**REPORT TO THE LAKES VEGETATION AND LANDSCAPING COMMITTEE**

<b>TO:</b>	The LVL Committee	<b>FOR:</b>	05/03/2022 LUFPC meeting.
<b>VIA:</b>	Carlos Dougnac, Assistant Vice President, PDC	<b>FROM:</b>	James Vignola, PD&C Project Manager
<b>REQUESTOR:</b>	UF Planning / PD&C	<b>PRESENTERS:</b>	James Vignola, PDC Project Manager and Jeremy Marquis, RLA (Consultant, ML+H)

Design Development (DD)

**MP06934**  
**University of Florida**  
Landscape Master Plan  
**Physics Shared Use Path**  
Design Development Submittal

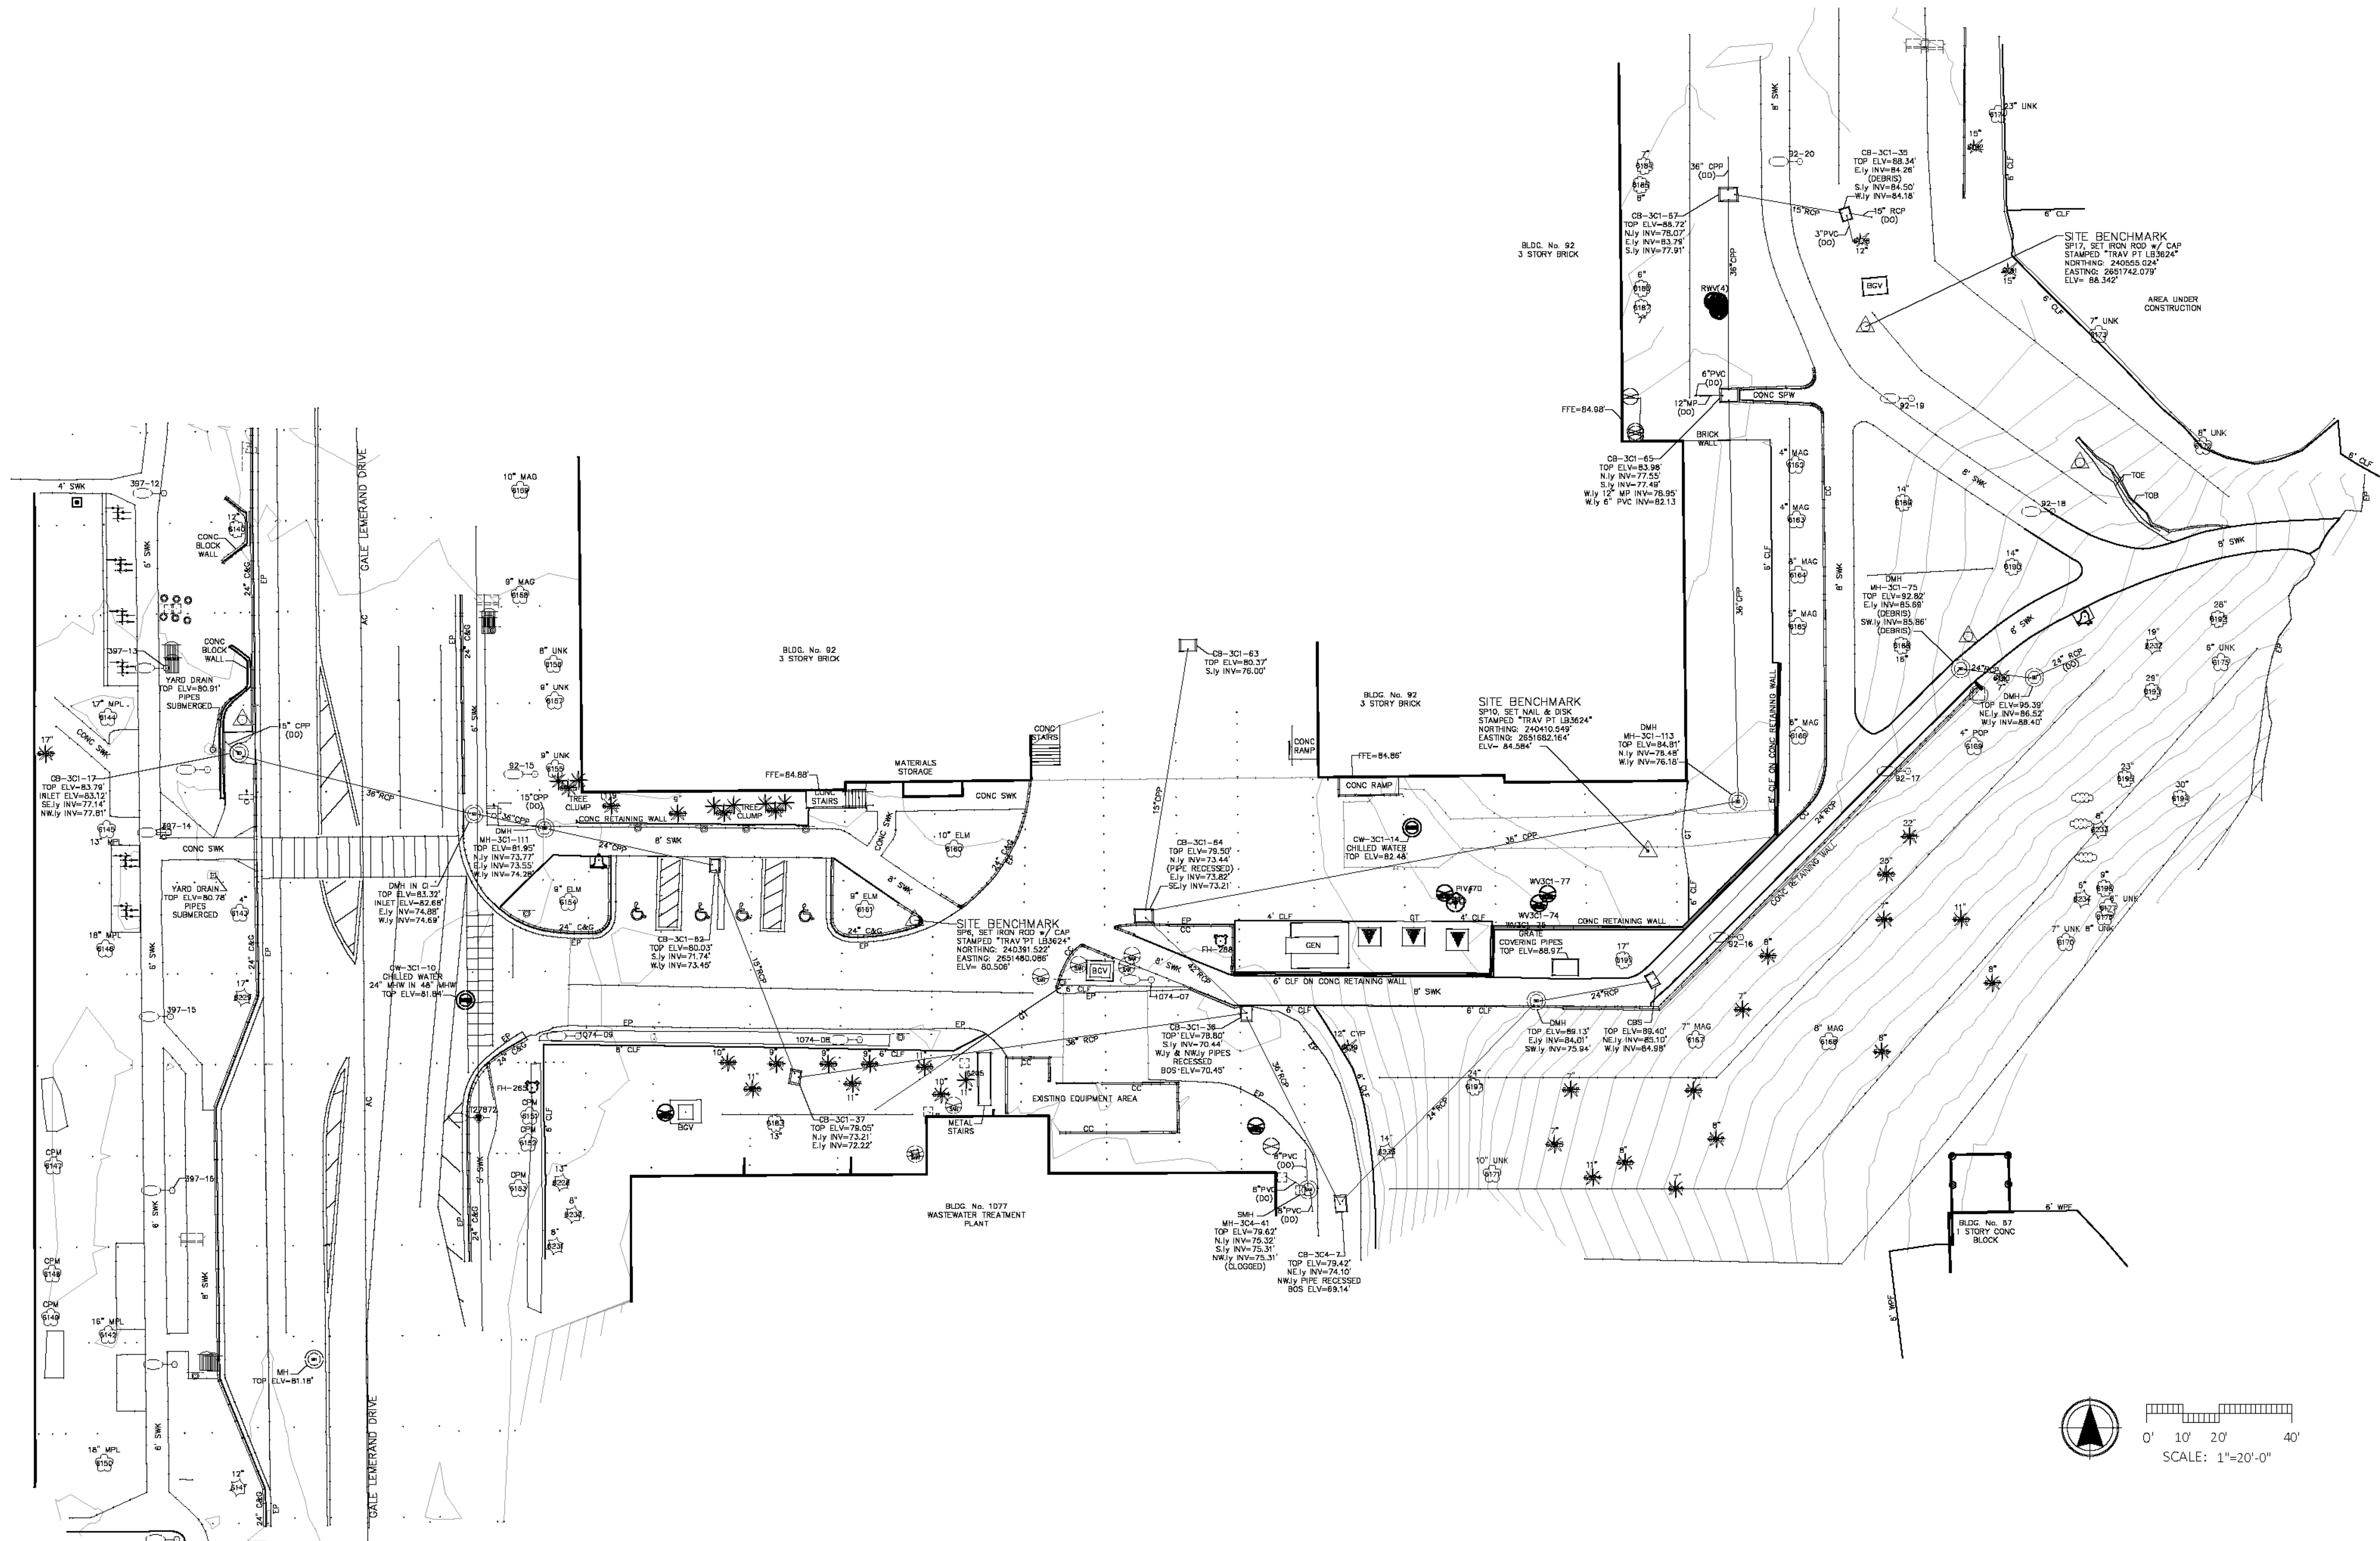
## **FEEDBACK FROM PREVIOUS COMMITTEE MEETINGS & CONTRACTOR**

### PTAC COMMITTEE:

- Add **motor traffic control devices** to both ends of the shared-use path.
- **Shift crosswalk signals** on Gale Lemerand Dr southward to lineup with relocated crosswalk.

### LVL COMMITTEE:

- Continue coordination with the Astronomy Department to minimize any adverse impacts.
- Efforts to **preserve or relocate existing vegetation** is appreciated.

### LUFPC COMMITTEE:

- Remove and relocate existing **UF Paving Mosaics**.

### CONTRACTOR (AJAX):

- Contractor has experience **relocating** palms & trees.
- Contractor able to relocate existing **Blue Light Emergency Phones**.

- **Accessibility** to helium tanks & loading area should remain clear.

- **Bollard lights are preferred** over pole lights due to reduced light pollution.
- Existing down-lights on-site work well. **Relocate existing down-lights** where possible.
- The **viewshed to the north** should remain clear of tall trees.

- Proposed realignments or circulation routes at the WWTP have been **reviewed & approved** per the Superintendent, Jared Howard.
- The southern turnaround should permit a **50' truck** to back in.
